<b>Docket Number:</b>	17-BSTD-02
<b>Project Title:</b>	2019 Title 24, Part 6, Building Energy Efficiency Standards Rulemaking
<b>TN #:</b>	223245-19
<b>Document Title:</b>	2019 Reference Residential Appendix (RA) Revised Express Terms
<b>Description:</b>	2019 Reference Residential Appendix (RA) Revised Express Terms
<b>Filer:</b>	Peter Strait
<b>Organization:</b>	California Energy Commission
<b>Submitter Role:</b>	Commission Staff
<b>Submission Date:</b>	4/20/2018 10:34:58 AM
<b>Docketed Date:</b>	4/20/2018

# ***Residential Appendix RA Appendix RA1 - Alternative Residential Field Verification and Diagnostic Test Protocols***

Figure RA3.5-1 Homes with Conditioned Space Over Garage – Batt and Blanket Insulation

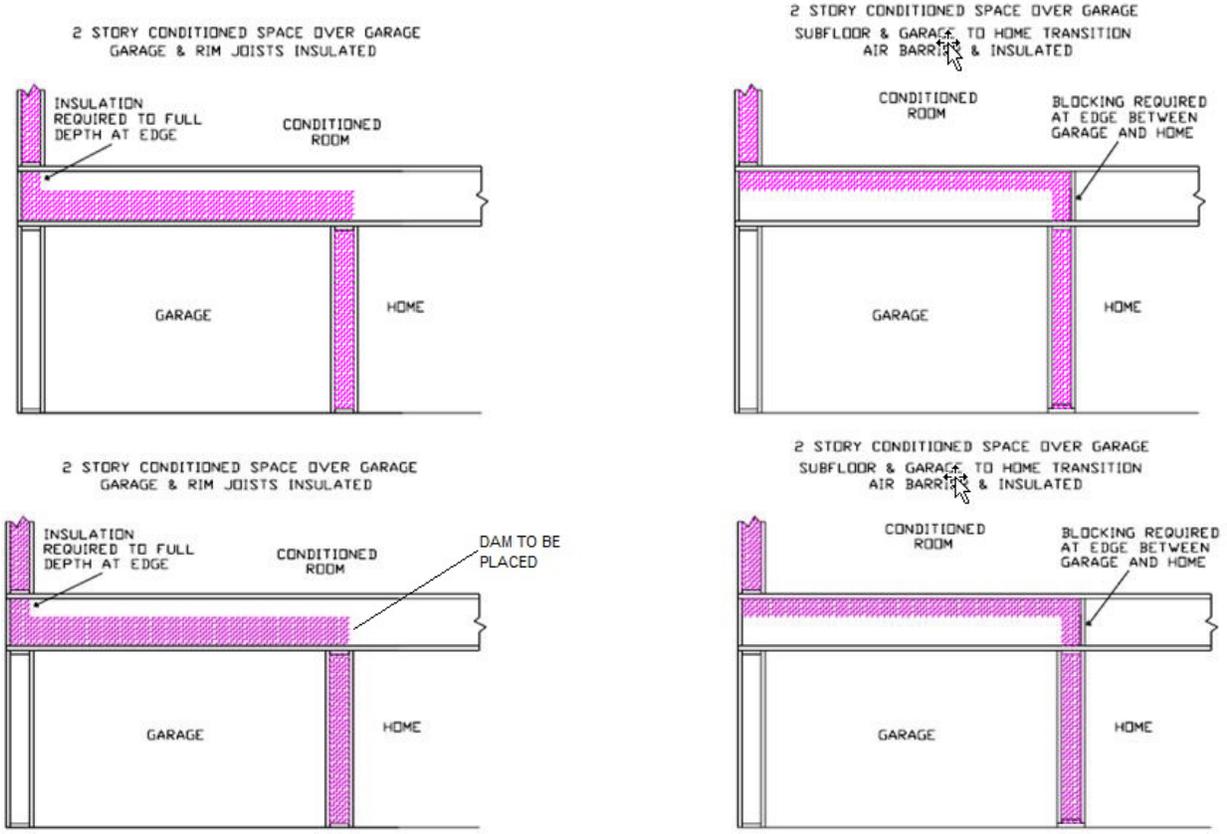
~~The floor over the garage shall be insulated with batt or blanket insulation against the subfloor of the conditioned space. The garage and the adjacent conditioned space (house) shall be insulated up to the subfloor. All rim and band joists adjoining conditioned space shall be air tight and insulated. The separation between conditioned space (house) and the garage shall be insulated to create a continuous thermal barrier. All rim and band joists adjoining conditioned space shall be air tight and insulated.~~

Figure RA3.5-5 Homes with Conditioned Space Over Garage – Rigid Board Insulation

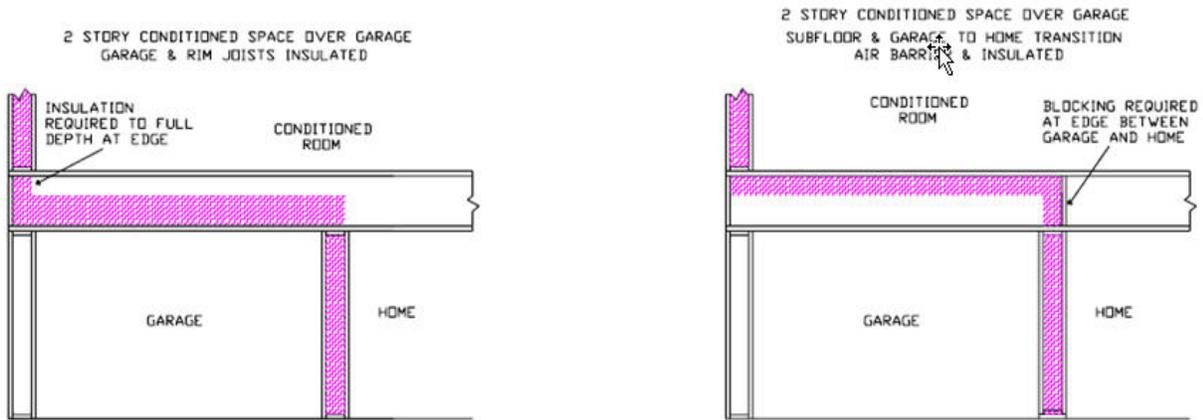
~~The floor over the garage shall be fully insulated with fully supported rigid board insulation against the subfloor of the conditioned space. The garage and the adjacent conditioned space (house) shall be insulated up to the subfloor. All rim and band joists adjoining conditioned space shall be air tight and insulated. The separation between conditioned space (house) and the garage shall be insulated with fully supported rigid board insulation to create a continuous thermal barrier. All rim and band joists adjoining conditioned space shall be air tight and insulated.~~

Figure RA3.5-7 Homes with Conditioned Space Over Garage – Spray Polyurethane Foam Insulation

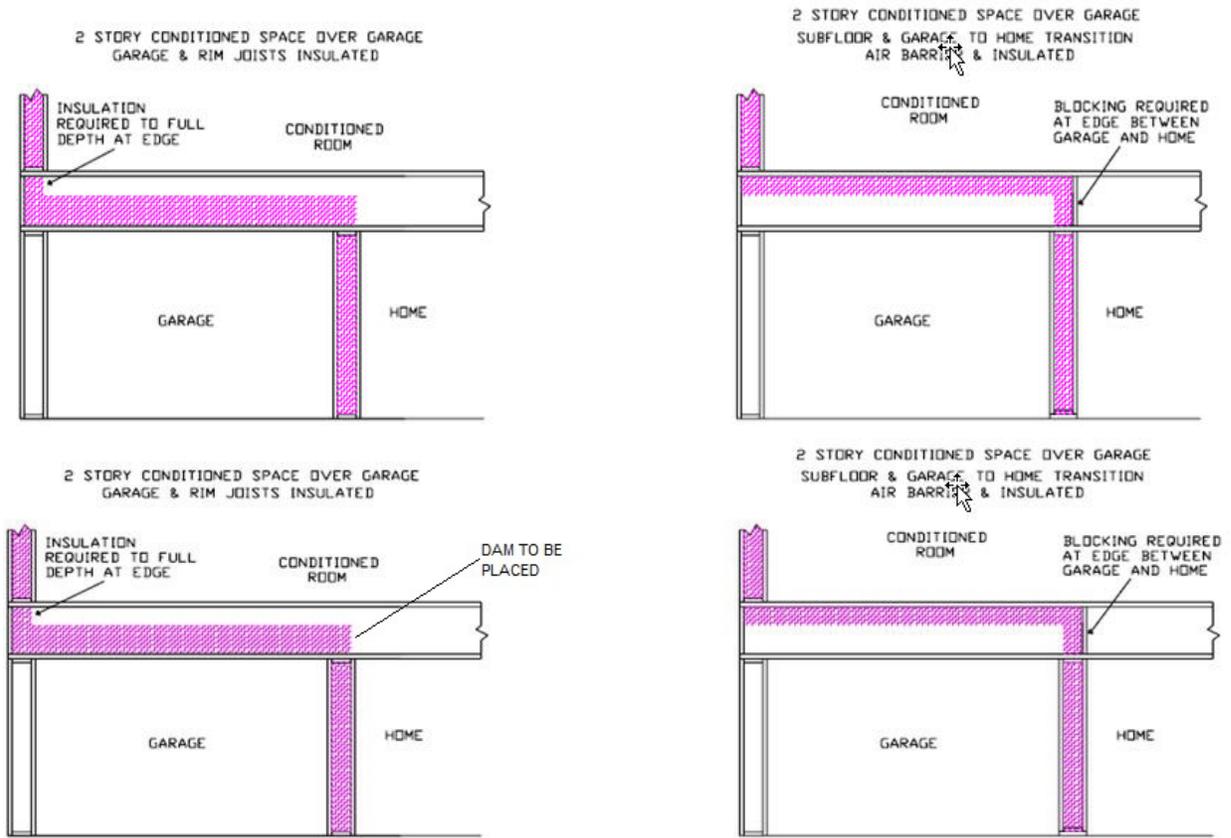
~~The floor over the garage shall be insulated by spraying SPF insulation to fully adhere to the subfloor of the conditioned space. The garage and the adjacent conditioned space (house) shall be insulated up to the subfloor. SPF insulation shall cover any gaps between the header and the floor joist. The separation between conditioned space (house) and the garage shall be insulated by spraying SPF insulation to create a continuous thermal barrier. All rim and band joists adjoining conditioned space shall be air tight and insulated.~~

Figure RA3.5-11 Homes with Conditioned Space Over Garage – Insulated Concrete Form (ICF)

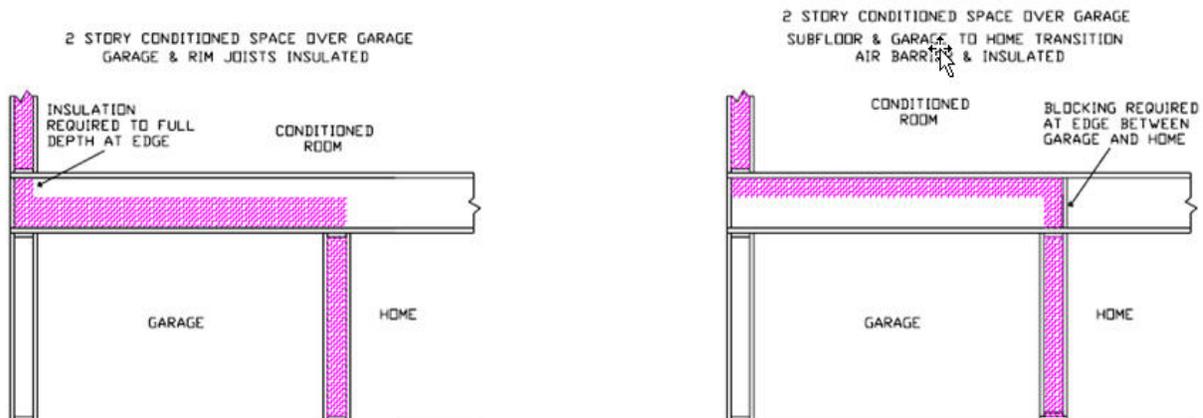
~~The floor over the garage shall be insulated. The garage and the adjacent conditioned space (house) shall be insulated up to the subfloor. All rim and band joists adjoining conditioned space shall be air tight and insulated. The separation between conditioned space (house) and the garage shall be insulated to create a continuous thermal barrier. All rim and band joists adjoining conditioned space shall be air tight and insulated.~~
